Appl. No. 10/616,186 Response dated January 12, 2005 Reply to Office action of October 12, 2004

Amendments to the Drawings:

Annotated Sheets Showing Changes

F16, 1

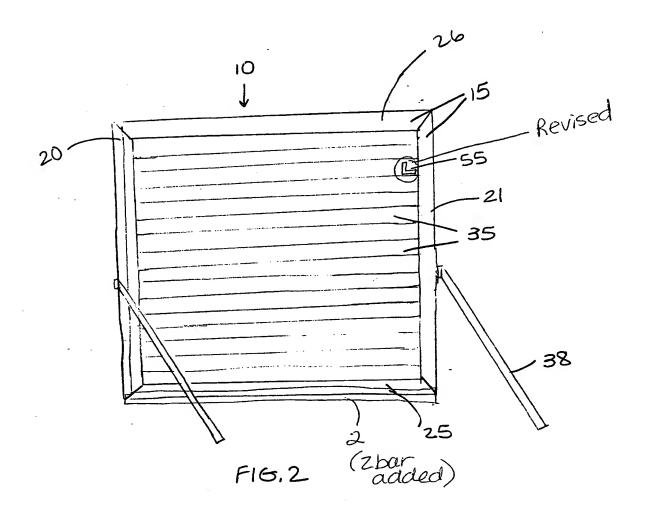
The attached sheets of drawings include changes to Figures 1, 2, 3 and an additional drawing sheet to include every feature of the invention specified in the claims in accordance with 37 C.F.R. § 1.83(a). Figure 1 has been revised to include the predrilled holes. Figure 2 has been revised to include the Z bar and a more clear representation of the L-angle bracket. Figure 3 has been revised to include cross sectional shading. Figure 4 has been added to show a bar extending vertically across the louvers and Figure 5 has been added to show a winding crank mechanism.
